# TECHNICAL REPORT

Cylinder head gasket VW  
Crafter / Amarok 2.0 TDI  
10195900-10220400

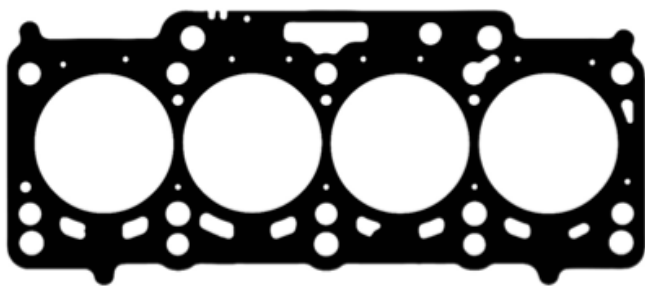
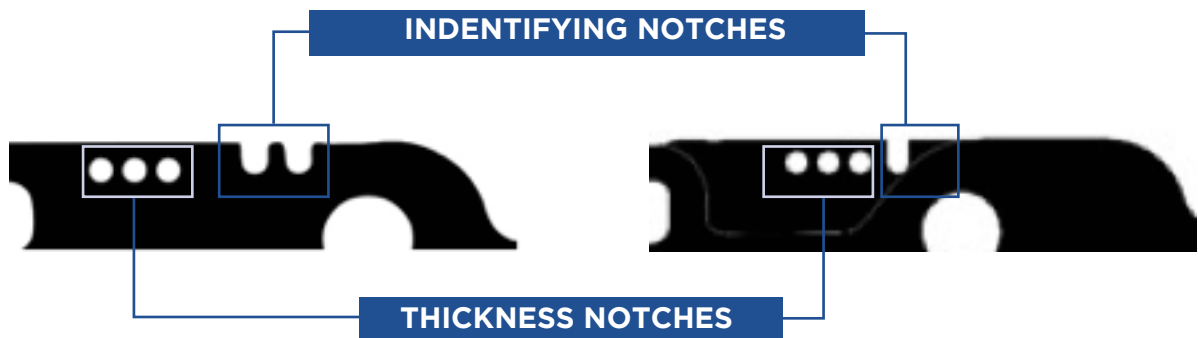
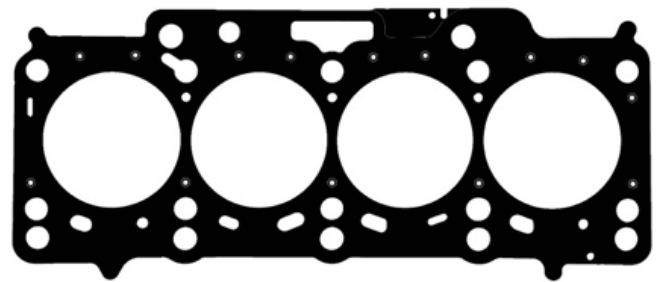
The 2.0 TDI engines mounted in VW Crafter and Amarok vehicles, has experimented a change in the cylinder head gasket reference in October 2013, substituting the old reference 10195900 to 10220400.

On the replacement of the cylinder head gasket, it must be **taken special care in selecting the correct gasket** according to the manufacturing date of the vehicle.

If the manufacturing date is not clear, it's also possible to identify the correct gasket that must be installed by observing the identifying notches of the old one.

NOTCHES		AJUSA P.N	OEM VW
LOCATION	#		
	1	10195900	03L103383BM
	2	10195910	03L103383BN
	3	10195920	03L103383BP

NOTCHES		AJUSA P.N	OEM VW
LOCATION	#		
	1	10220400	03L103383DC
	2	10220410	03L103383DD
	3	10220420	03L103383DE
